**Title:** Authorization to Amend Funding Agreement for the Morningside Stormwater Improvement Project

**Resolution number:** 26-051

Project/File: Morningside Ravine Stabilization

## Reference: Morningside Ravine Stabilization

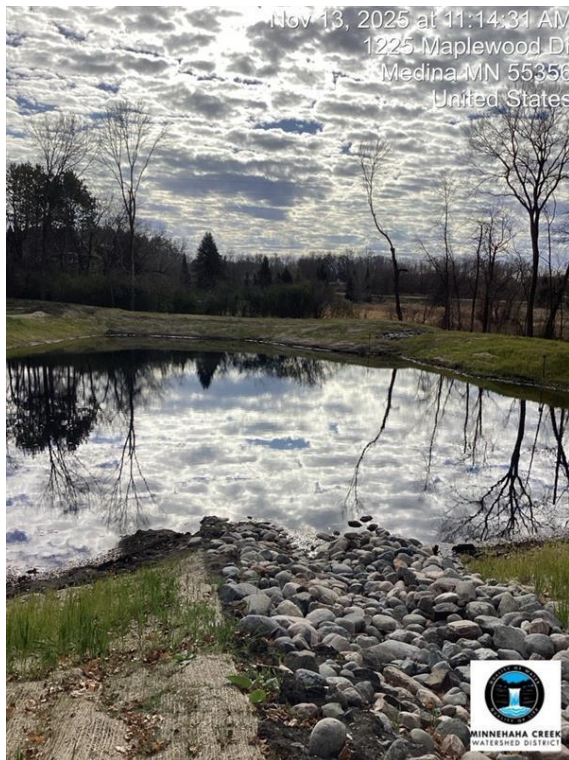
In addition to the grading around the weirs, the plan details show class IV riprap, fabric and filter aggregate to assist in stabilizing the riprap. The photos from the site visit show exposed topsoil at the riprap tie in and coming through the riprap in the plunge pool and side slope areas. The intent of the fabric and filter aggregate, as shown in the detail, is to provide material separation between the riprap and underlying soils. The presence of topsoil makes it unclear if the area meets the design standards and creates a risk of sedimentation in the riprap pools and the pond before the project is complete. Stantec recommends verifying filter fabric and aggregate have been provided in these areas, remove any excess sediment and provide additional riprap to fill in voids.

The eastern channel was planned for grading, class III riprap and bio-engineering methods to stabilize the eroded banks. The site visit photos show riprap slipping, sedimentation starting within the channel, and side slopes not stabilized. It appears there was not sufficient riprap placed to stabilize this channel. The recommendation for the eastern channel is to remove any excess sediment and to provide additional riprap at tie ins and in the channel bottom as necessary to stabilize the channel. Filter aggregate may be utilized under the riprap to assist with material segregation and riprap stabilization. We are also requesting verification that live stakes and other bio-engineering solutions have been utilized to assist in the stabilization of these ravines per the plan callouts. If blanket and lives stakes are not provided on bare side slope soils, additional riprap can be used to stabilize side slopes.
